Southwark Council  
Development Management  
Chief Executive's Department  
London SE1P 5LX

Date: 15 November 2022

## **22/EQ/0015 – Aylesham shopping centre, Rye Lane, Peckham**

### **The current options**

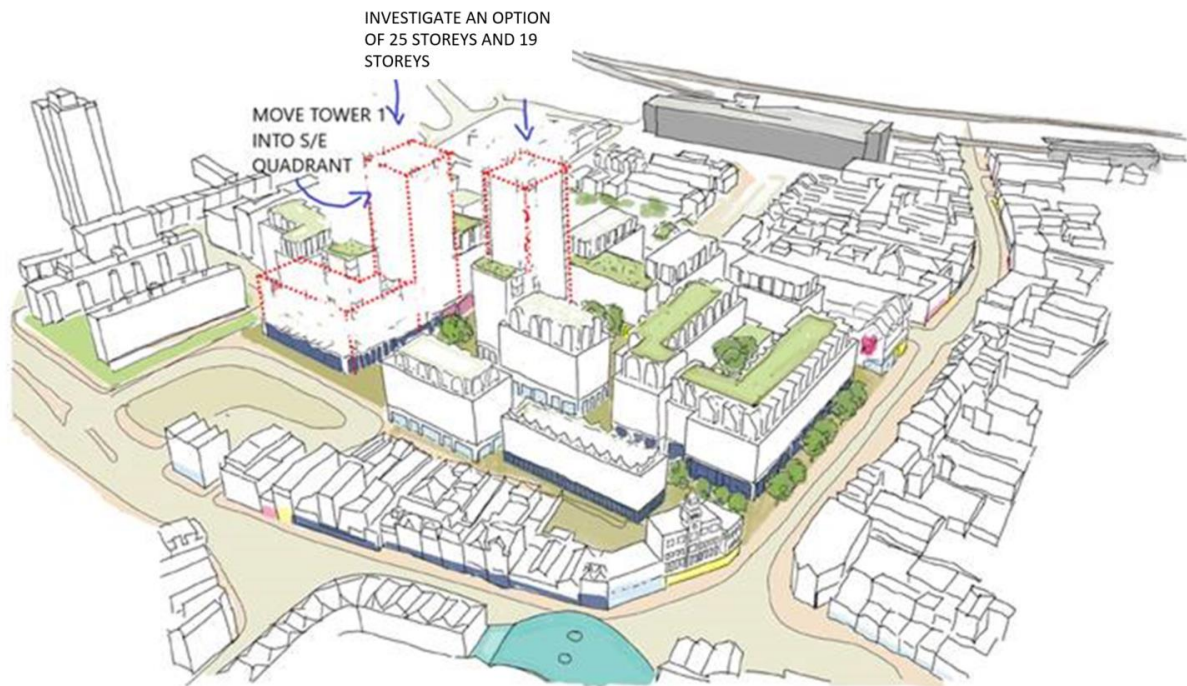
- Options 1 and 2 presented (2 Nov) included an increase in the number of tall buildings across the site (the ‘lower’ option includes 3 No 20-storeys and 1 No 18-storeys with heights along the western and northern edges of the site ranging between 12 and 14 storeys)
- The public realm is now concentrated in the east-west shopping street (12 – 15m in width) and north-south linear park (around 20m in width)
- The central square and the Rye Lane Square are omitted
- New north-south ‘alley’ introduced

The information presented raised a number of issues about the, height and the conservation area, the new public spaces, the Masterplan and streets, and the architectural quality and amenity
